Dunkin

Donuts/Valvoline

20290 GRANDE OAK SHOPPES BOULEVARD

# Valvoline Elevation

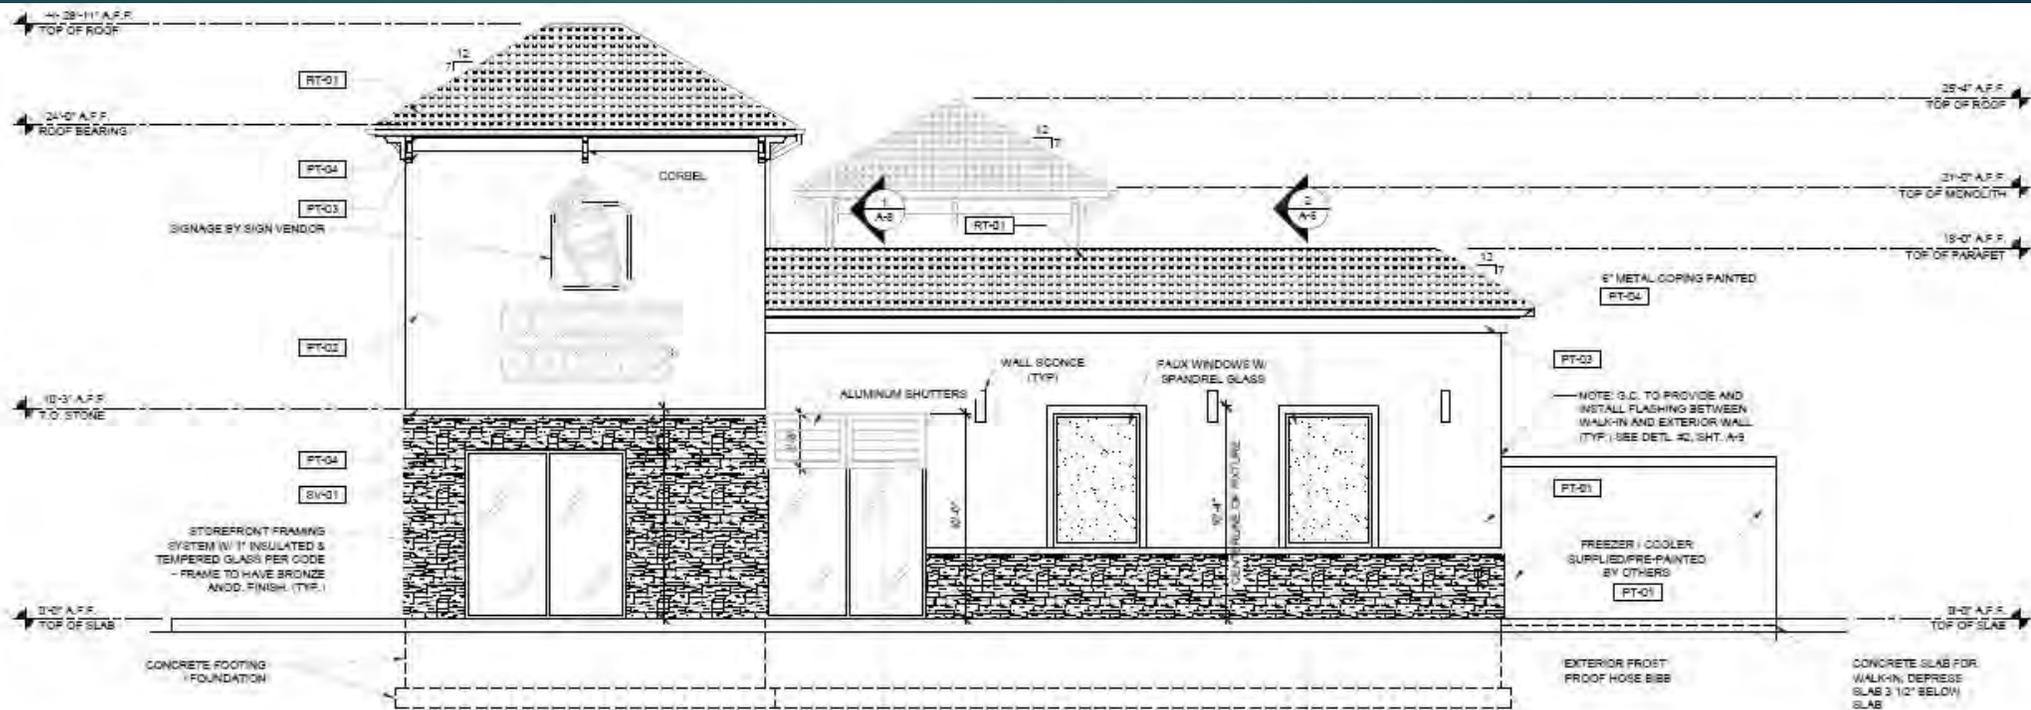
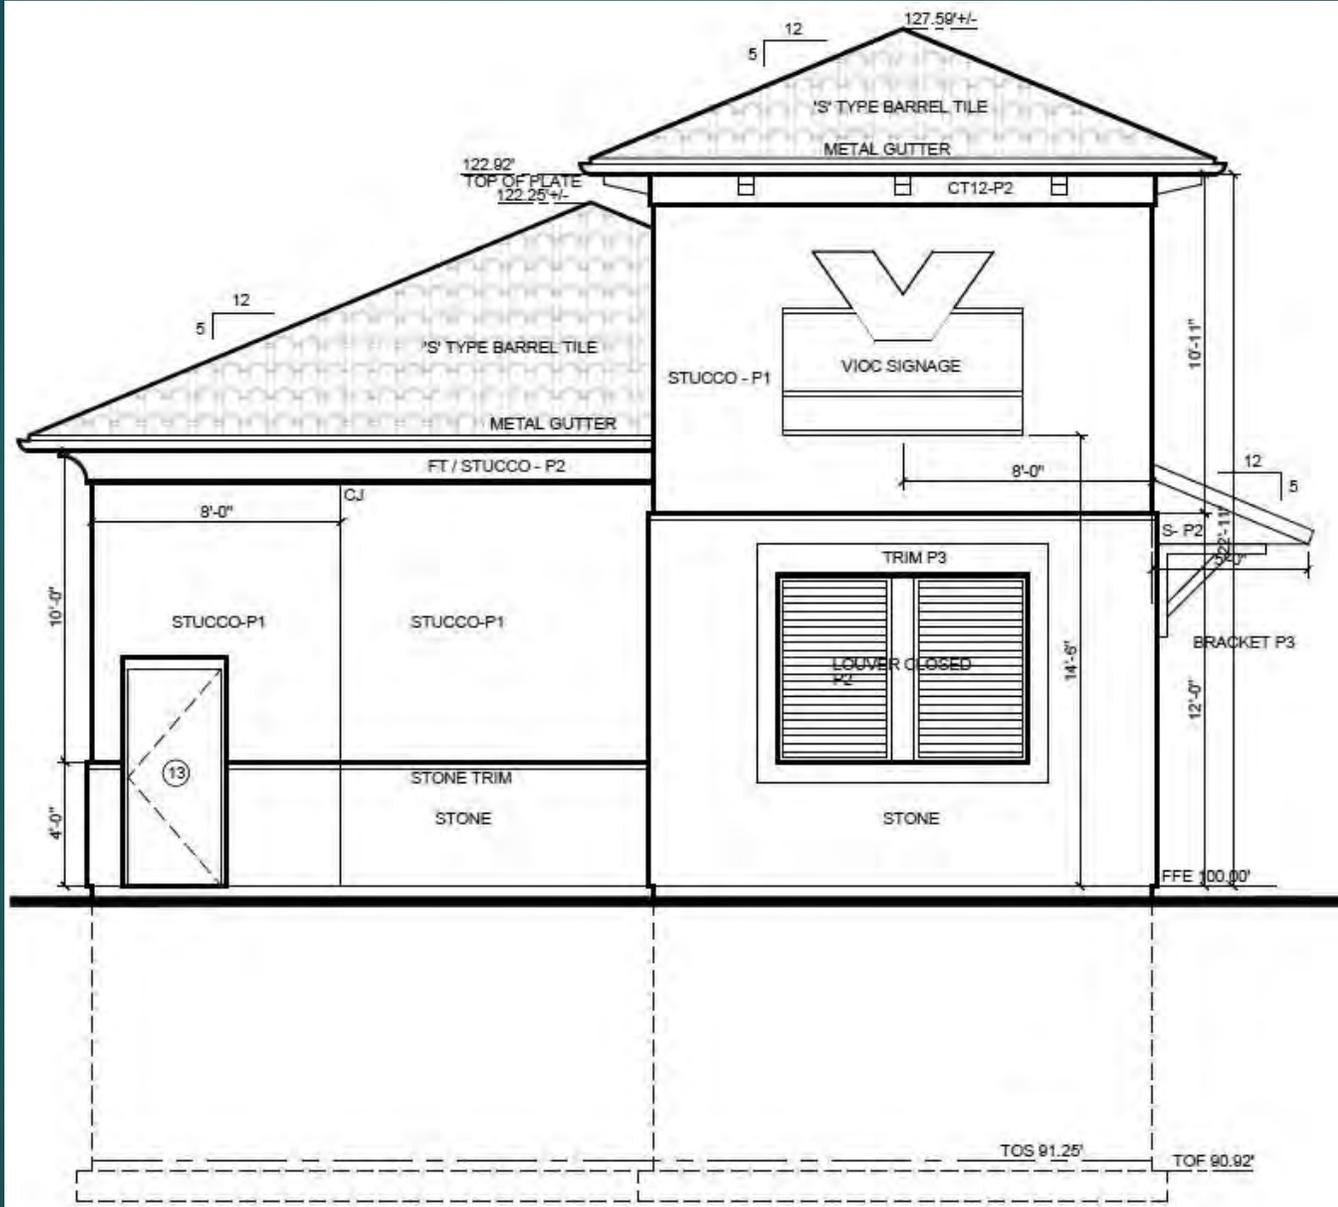
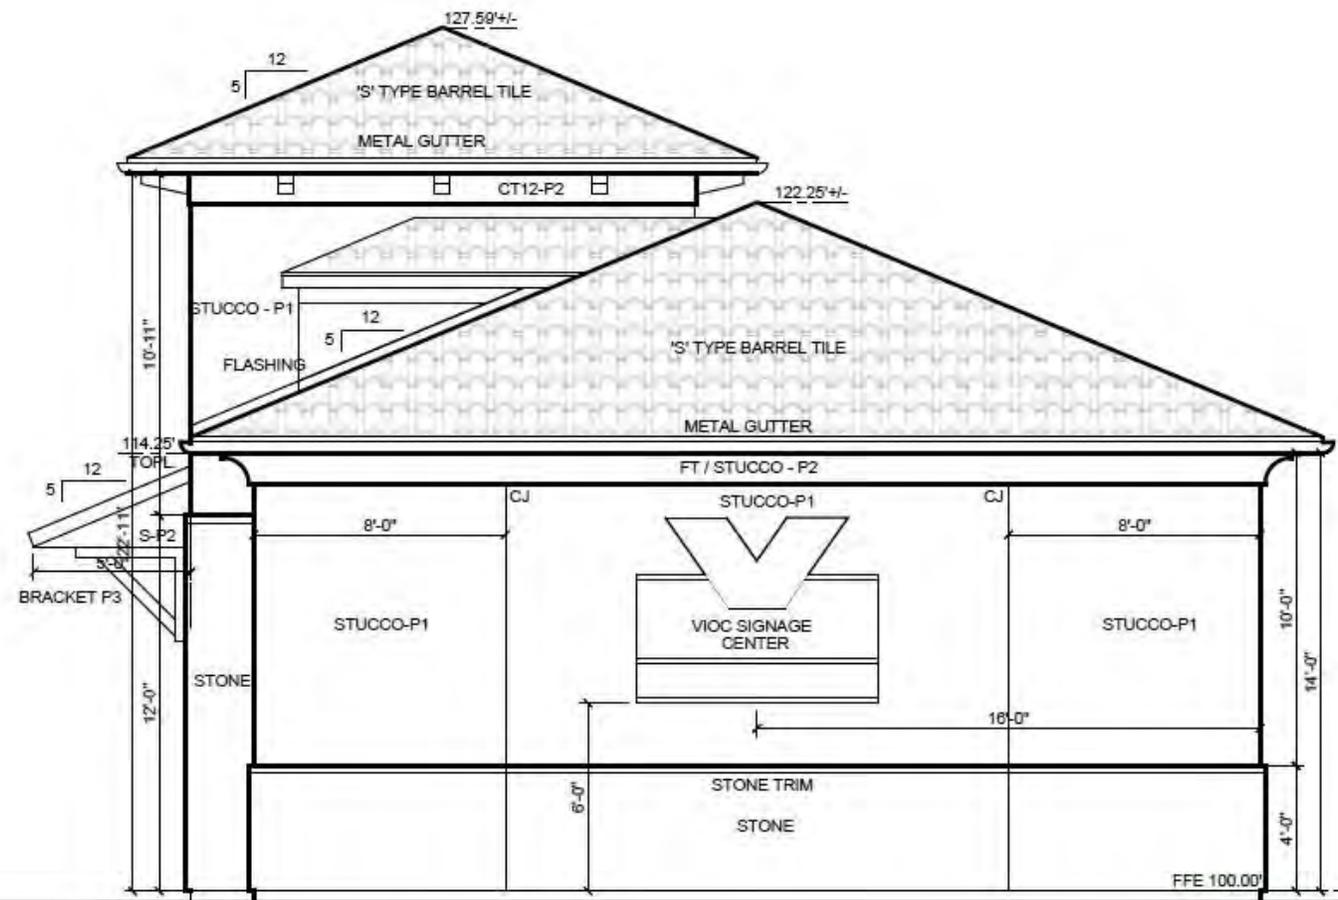
# Valvoline Elevation Changes Since Last DRB

- ▶ Two dormers added to West Elevation, hip roofs with proportional profiled edge with two louvers
- ▶ Entry canopy with support brackets on main tower customer entrance
- ▶ Added faux window with appearance of two shutters on the north elevation
- ▶ Reconfigured tower roof edge detail to a flat trim with formally located faux beams
